# Analysis of BC Hydro's Proposed Changes to the Generating Station and Spillway Design for the Site C Clean Energy Project

June 2018

**Figure 2. Conceptual Drawing of Generating Station and Spillway per Modified Design**

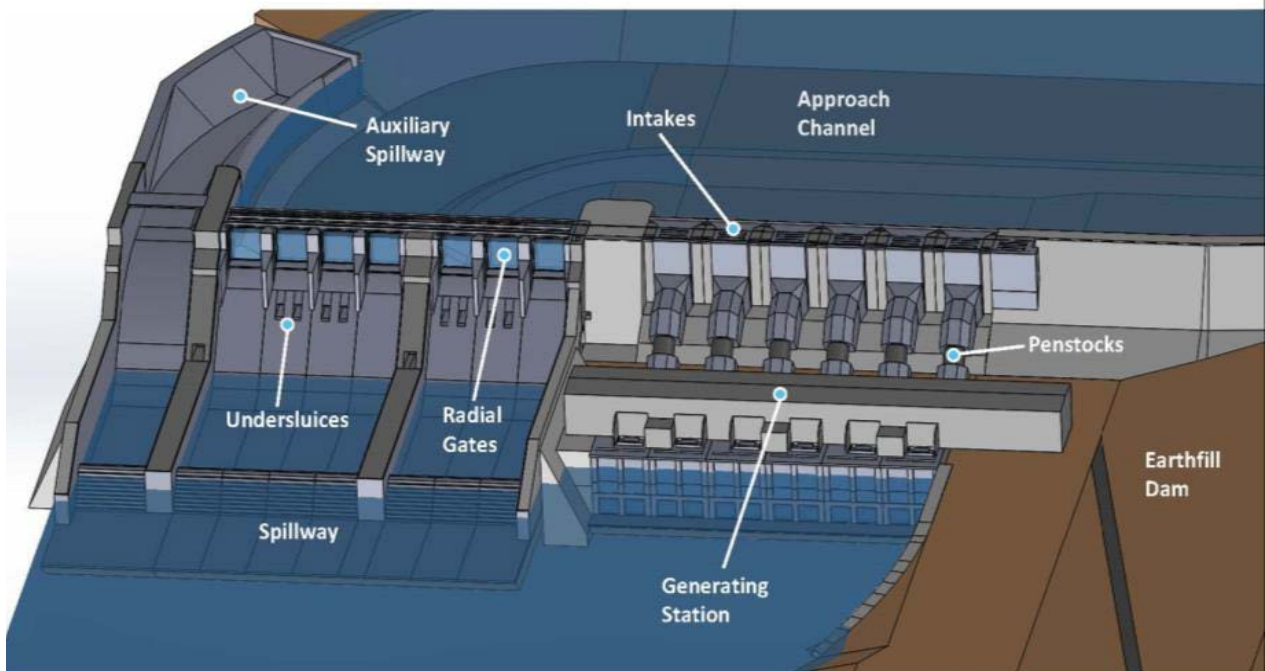
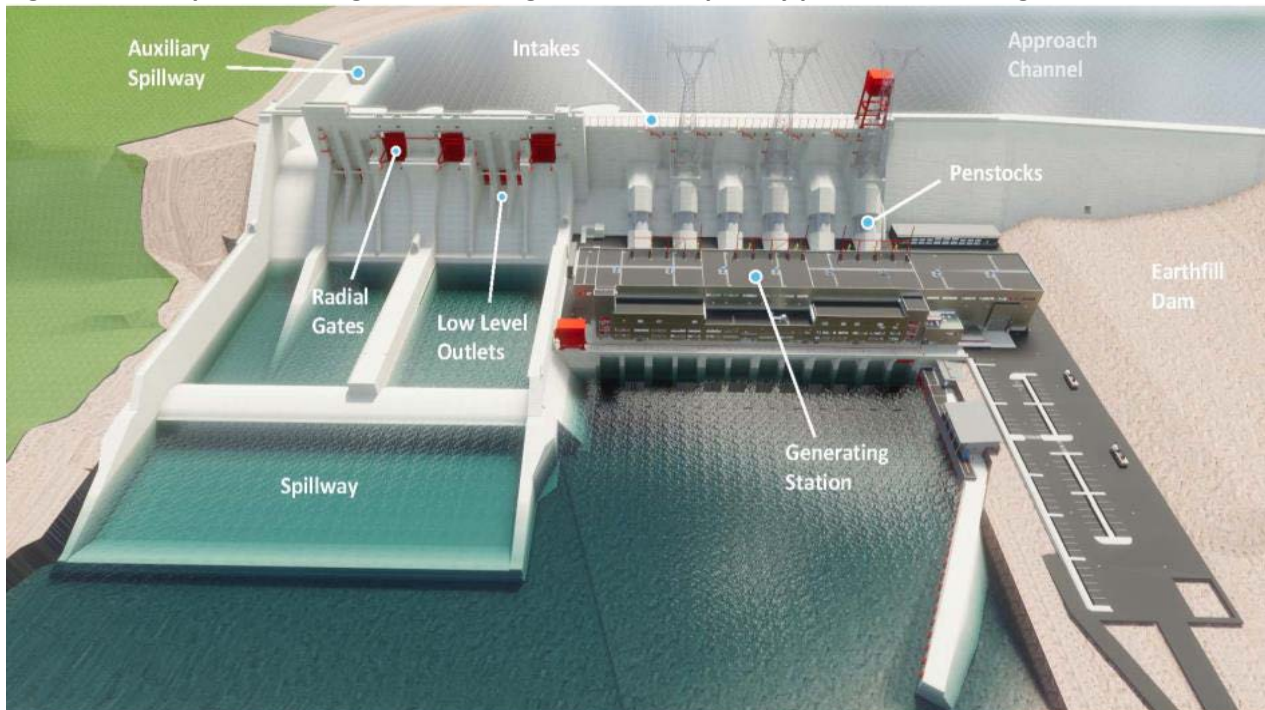
In the Environmental Impact Statement, BC Hydro specified that the transformers would be located on the downstream side of the powerhouse. Instead, BC Hydro has proposed that the transformers be located on a transformer deck upstream of the powerhouse. This would eliminate the risk of an oil spill in the tailrace in the event of a catastrophic failure of a transformer and would reduce noise pollution downstream of the facility.

The Environmental Impact Statement described a spillway design with seven radial gates, eight undersluices (e.g., covered gates) and an auxiliary spillway to provide additional flow capacity in the unlikely event that some or all of the seven spillway gates become inoperable during an emergency. BC Hydro's proposed design change provides for three radial gates, six low level outlets, and an auxiliary spillway. These changes are expected to optimize the capacity of the spillway and reduce undesirable hydraulic pressures by reducing the width of the spillway and lowering the elevation of the stilling basin. BC Hydro expects this change will increase the safety and reliability of the spillway operation.

The revised design would provide an increased discharge capacity at the normal reservoir elevation. Under the Environmental Impact Statement design, the capacity of the spillway at the full supply level of 461.8 meters would be 10,100 cubic meters per second ( $m^3/s$ ). The revised design increases this capacity by 900  $m^3/s$  to 11,000  $m^3/s$ . As a result, the spillway is less likely to increase (surcharge) the reservoir elevation under extreme high flow scenarios. The ability of the spillway to discharge more water at

The Environmental Impact Statement also described the spillway as having a discharge capacity of 17,300 m<sup>3</sup>/s at the maximum flood level of 466.3 meter elevation. This is the maximum permissible reservoir level during the most severe flood that may be reasonably expected to occur. Because BC Hydro's revised spillway design would pass a greater volume of water at normal elevations, the maximum flood level of 466.3 meters would be even less likely, i.e. less than 1 in 1000 years. Should this unlikely event occur, the revised spillway design discharge capacity of 16,700 m<sup>3</sup>/s would safely convey the probable maximum flood volume and maintain a reservoir level below 466.3 meters.

The Agency accepts the proponent's determination that the design changes to the generating station and spillway would not result in any additional adverse environmental effects to fish and fish habitat as assessed through the initial environmental assessment. The Agency is therefore not proposing any changes to the mitigation measures previously identified in the environmental assessment.
